Mealstream EC501 (Series 5) CTM3 240V, 60Hz
FCC ID: PCVCTM3246015A
FCC Class II Permissible Change

Description of changes

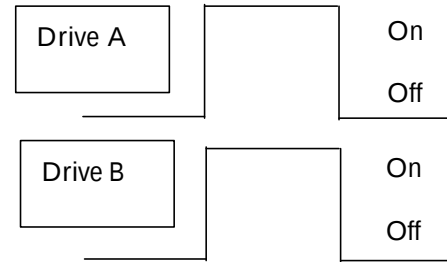
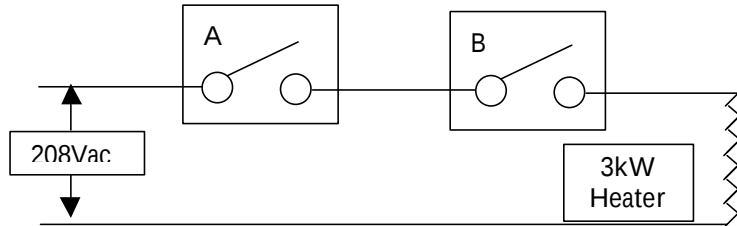
5. Inclusion of Opto-Triac (30Z1189) within the heater control circuitry.

Refer to the block diagram at the end of this document.

A Semiconductor Triac device has been added in the heater control circuitry. Before the modification, the convection heater element was controlled by two series connected relay contacts. The two relay contacts were operated sequentially but could be switched whilst current is flowing.

The modified circuit uses a Triac, which performs the function of zero crossing detection. This allows sequential switching of the relay contacts such that there is minimum current flowing when the relay switch contacts change over.

The control logic to drive the Triac is isolated from the mains switching voltages by means of an opto-isolated triac linked to the switching triac.
